Project Name Onion Hill – Preliminary Plan

Subject: Response to Review Comments - Onion Hill Subdivision
(City File 56-83)

FILE NO. #56-83 TITLE HEADING Onion Hill DUE DATE 12/12/83

Location: SE corner of 27½ Road and Cortland Avenue. A request for 123 units on 28 acres in a planned residential zone - PR 7.2.

PRELIMINARY PLAT FOR
ONION HILL

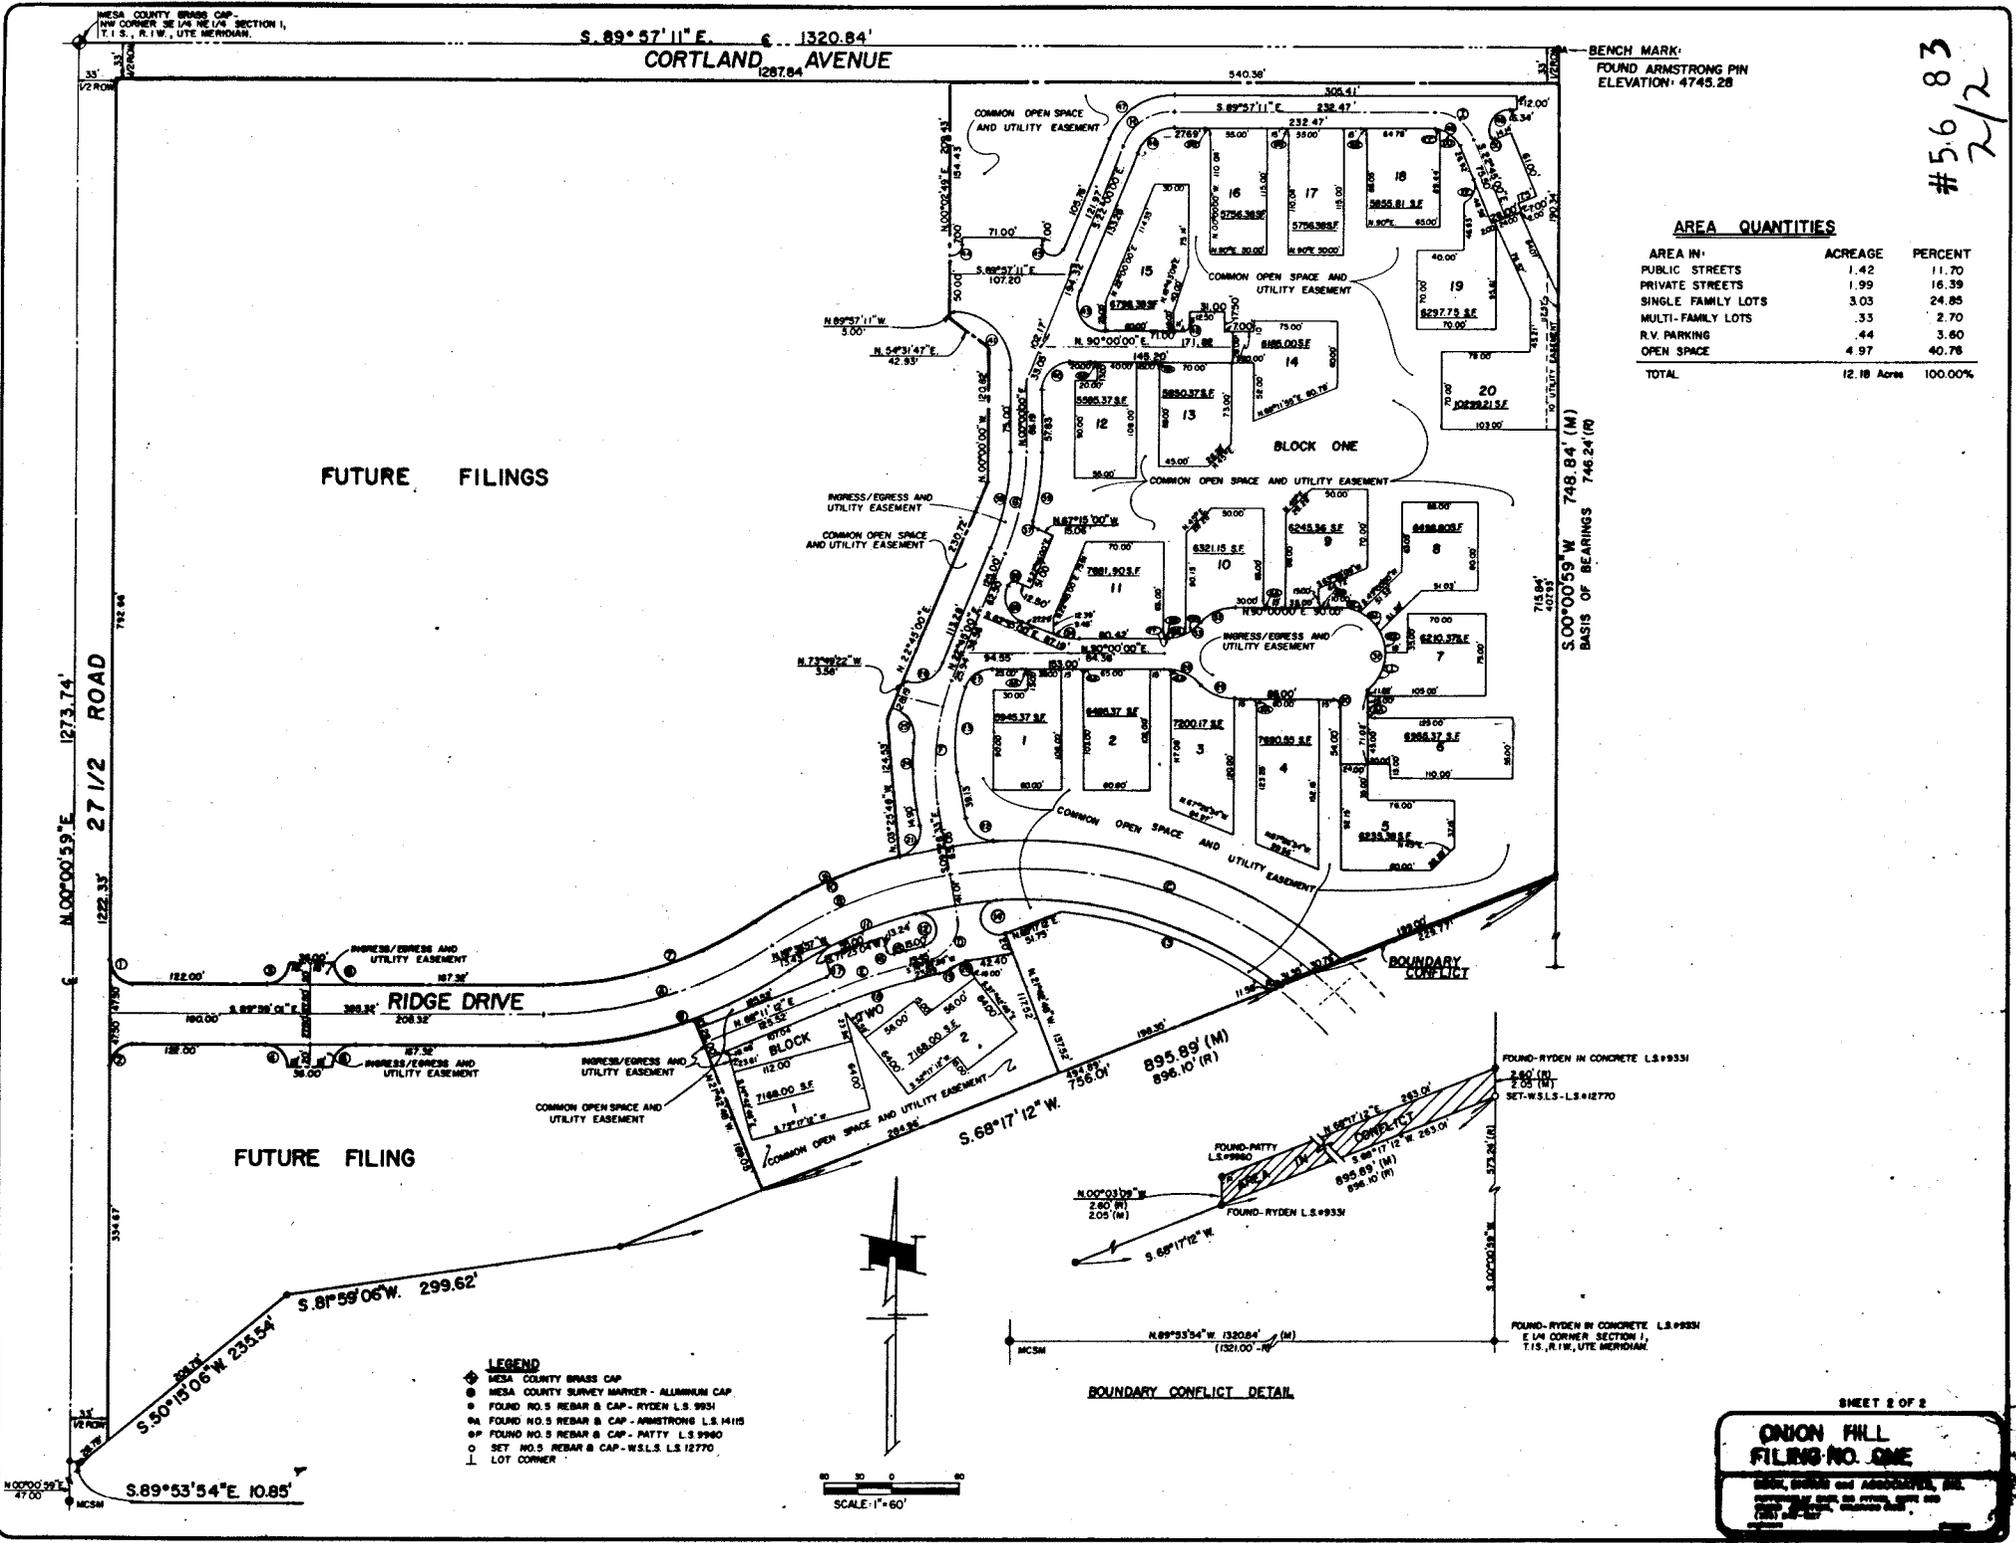
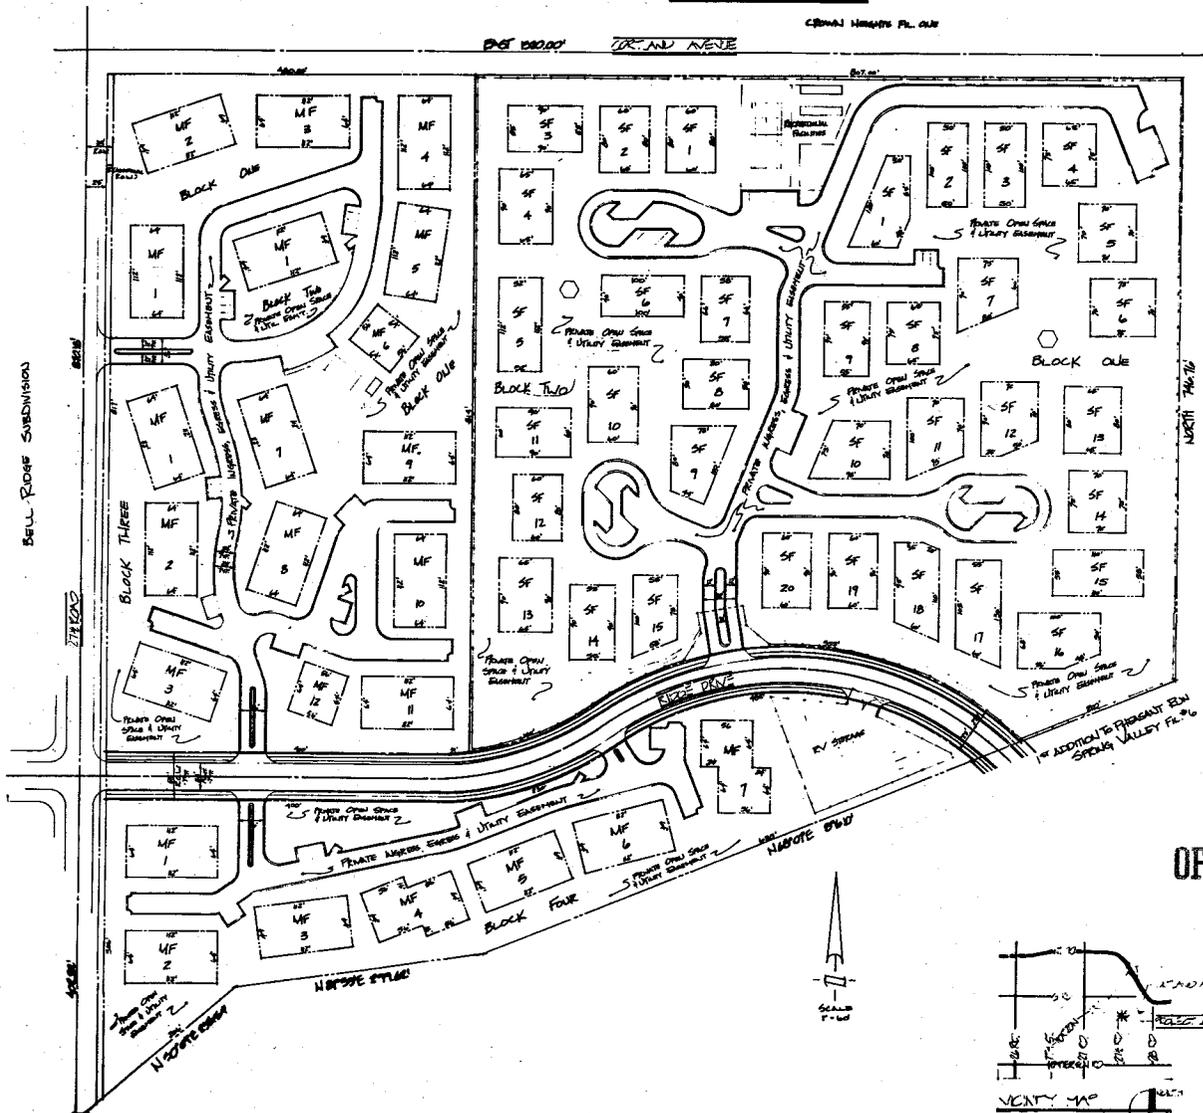
12/12/83	Grand Valley Water Users	This proposed plan does not address the needs of the G.V. Water Users Assoc. for adequate right-of-way and protection for its "existing underground irrigation" water pipeline located along the north boundary of the proposed development and as now drawn there are several items of concern. Such pipeline serves more than a hundred water users beyond this location and was allowed some 3+ years ago to be relocated from an adjacent open lateral at the request of the then-owners of Onion Hill with the understanding that future development would satisfactorily provide for the Assoc.'s relocated facility. The "Assoc." cannot approve Onion Hill's development until the above stated concerns are resolved and asks that "Planning" not approve it until they are resolved.
12/12/83	Walker Field	Avigation easement required per Section 5-11, City Zoning and Development Code.

1. A six-foot masonry fence is proposed to surround the single-family portion of the development. Who will maintain this? Will it be designed to harmonize with the area?

2. A guard-house is proposed at the entrance to the single-family area. How will police, fire, ambulance and trash services perform their duties if the gate keeper is away? Will a crash access be provided?

3. The private roadway within the development measures approximately 24' per the site plan. Is this roadway sufficient for trash and fire truck access? Those specific departments should be contacted for verification.

4. What roadway/driveway will serve pads 19 & 20 (Phase 1 - Single-Family)?
5. What will serve as pedestrian ways - both on the perimeter and in the interior of the development?

12. The proposed development lies within an airport critical zone. An aviation easement may be required.
13. On-site circulation appears cramped. Overflow parking backs directly into vehicular flow patterns. On-street parking (private drives) may hinder service delivery (fire, ambulance, etc.). Have modifications been considered?

I met with you on November 29, 1983 to discuss the irrigation requirements for the above referenced subdivision. The major topic of concern was the protection of the existing underground irrigation line along the Northern boundary of the project.

We are currently in the preliminary planning stage of the project and have not surveyed the exact location of the line. However, based on a field investigation, it appears that the line in question is located 26 feet South of the Courtland centerline within the City's street right-of-way. In addition, as shown on the preliminary plat of Onion Hill, all areas within the subdivision with the exception of the building lots will represent a utility easement. In other words, there is approximately a 25 foot easement between the property line and the nearest building as well as the space provided in the public right-of-way for maintenance purposes.

The final engineering drawings for the project concerning the irrigation system will be forwarded to your office for review after the exact location of the line is determined in relationship to the street centerline and the property line. Above all else, care will be taken to insure that the irrigation line is protected and that appropriate easements are recorded on the final plat.

- 4) Pads 19 and 20 of the single family, as well as all pads will be served by drives similar to those shown on the "Possible Pad Layout-Single Family" as submitted on the site plan sheet.

- 5) The new public street, Ridge Drive will have sidewalks on both sides. In the future as 27½ Road and Cortland are upgraded, they will have sidewalks. The entire perimeter will therefore have sidewalks at every possible location. A path is shown for the single family, serving most of the units. Its purpose is for relaxing walks more than inter-unit access. A very minimum of interior walks may be added at final, but only a limited number are wanted.

- 6) To our knowledge, the drainage problem created by the Apple Crest Subdivision has been solved by the installation of an underground irrigation pipe along the north boundary of Onion Hill. The City Engineer may want to verify the situation. Regardless of the situation, Onion Hill will not accept Apple Crest drainage through its property. The logical drainage course to serve Apple Crest is West along Courtland and South along 27.5 Road to the wash at Bell Ridge.

- 7) Our 6 foot wooden fence around the RV area is at least equal to any existing fence and similar residential fences permitted anywhere. Standard landscaping is proposed. To try and completely screen the screening is not warranted. We will provide bi-parting gates sliding to either side to eliminate the problem caused by swinging gates.
